# Landscape Memo

RM220834 (QLDC) / RC220255 (CODC) / RM22.434 (ORC)  
Cold Gold Clutha Ltd

To Hearings Panel  
From Richard Denney, Landscape Architect, DLA.

The hearing's panel have requested a written reply to the following questions in regard to the councils' landscape peer review report.

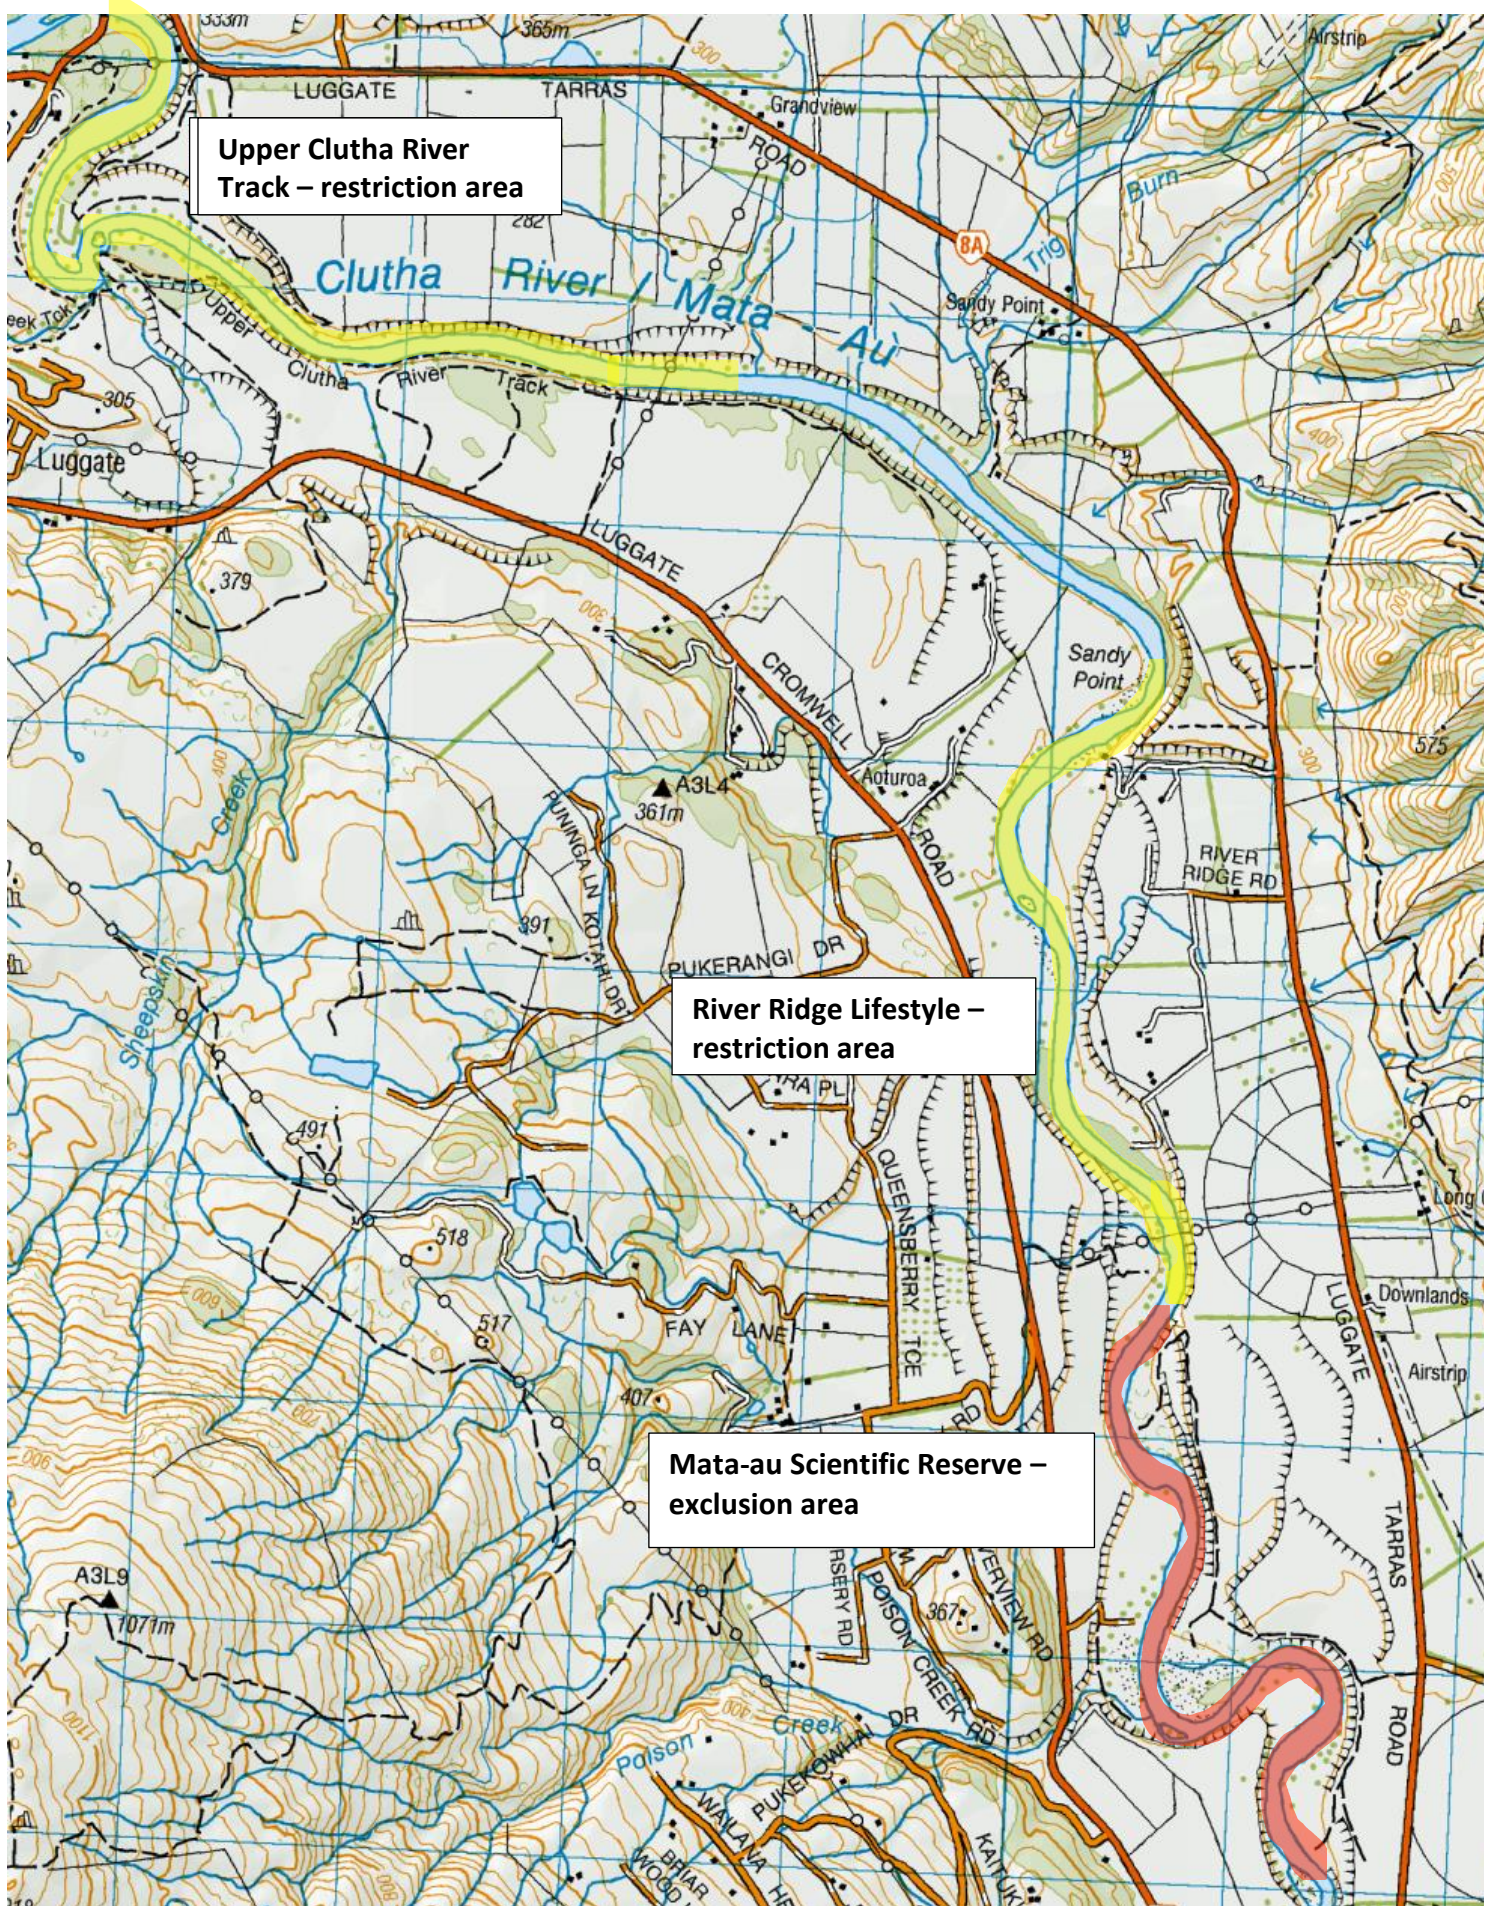
Mata-au Scientific Reserve (photos right), based from my site visit and understanding of the reserve struck me as an obvious area of exclusion. It has several overlaying landscape values, with a strong sense of containment and seclusion at river level dominated by a natural elements in riverside views, and from the terrace flats the extent of the reserve out to the highway had strong natural character as a context for the river landscape. The switch backs in the river at this location are particularly pronounced and dramatic. In terms of natural values these appeared to most prevalent at this location and as there is public access to the area I consider to be the more sensitive location in regards to the proposed activity in this context

Location of recommended restriction and exclusion areas. NZ TOPO Map

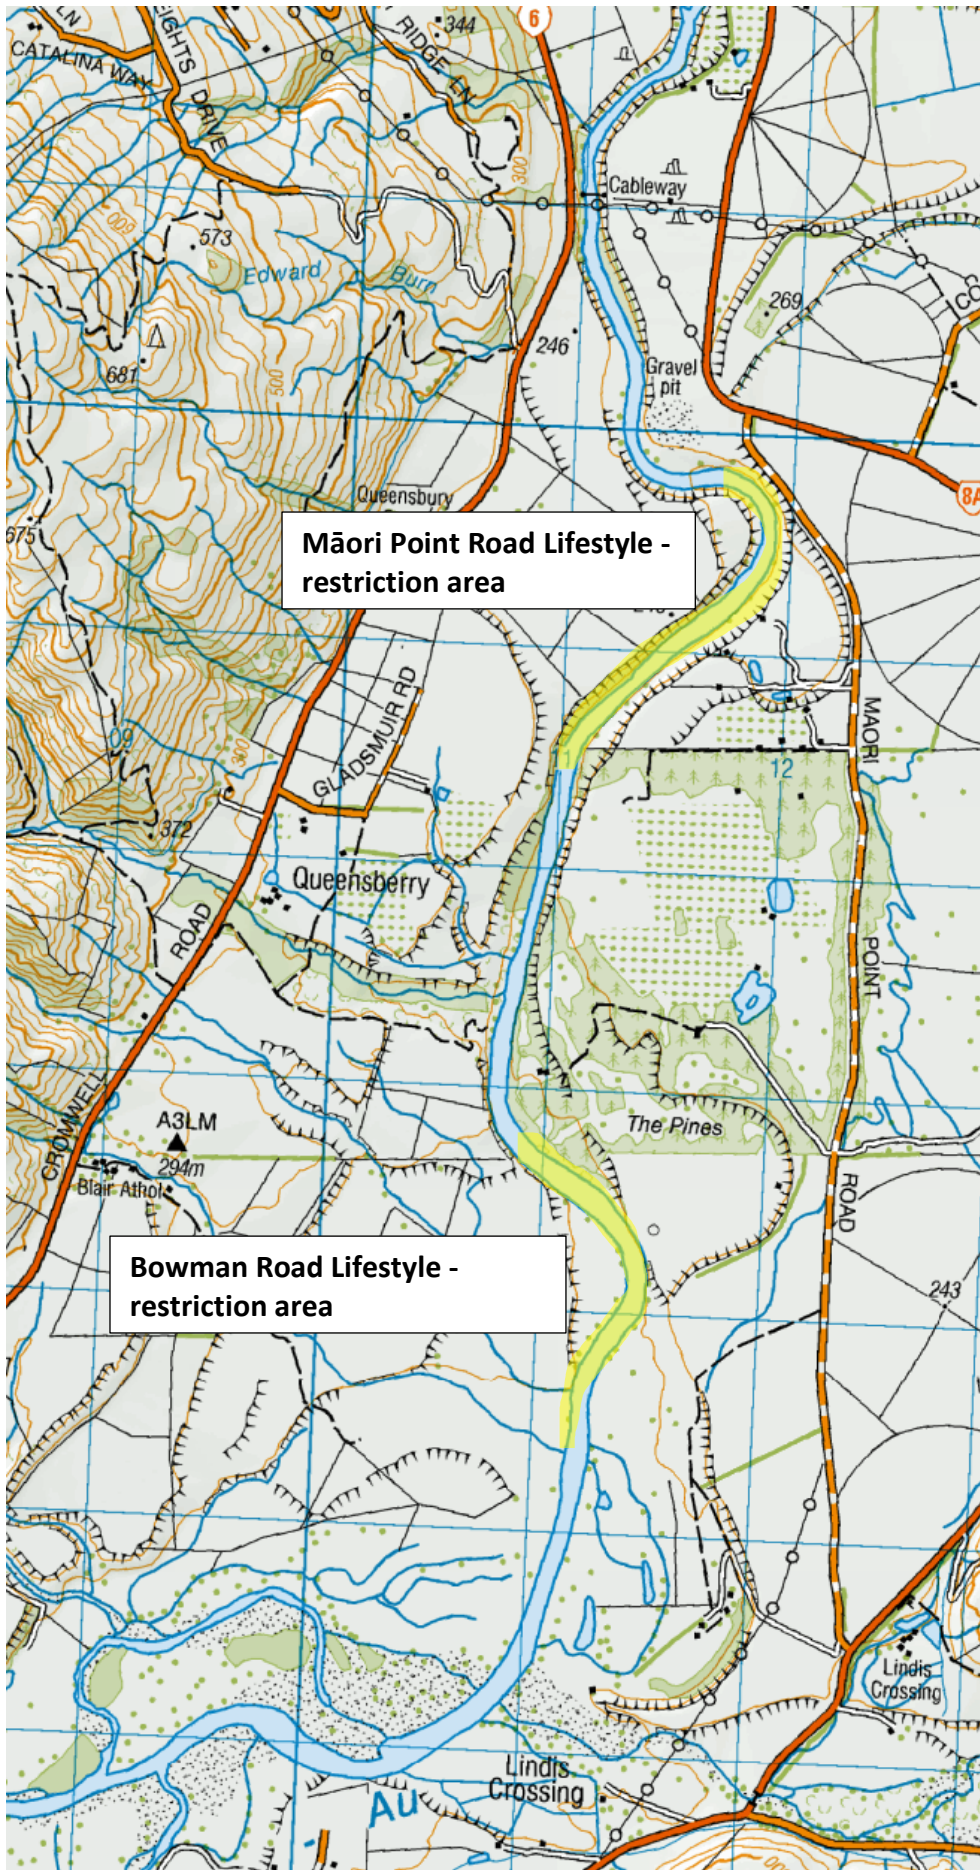
***The condition recommended underneath Para 69 references a number of areas, could you please supply a plan showing the exclusion areas?***

Attached, the areas shown are indicative to show the relative extent and location of areas. The exclusion areas within the application are not included on the plans, but taken as overriding any overlaps with the drawn restriction areas.
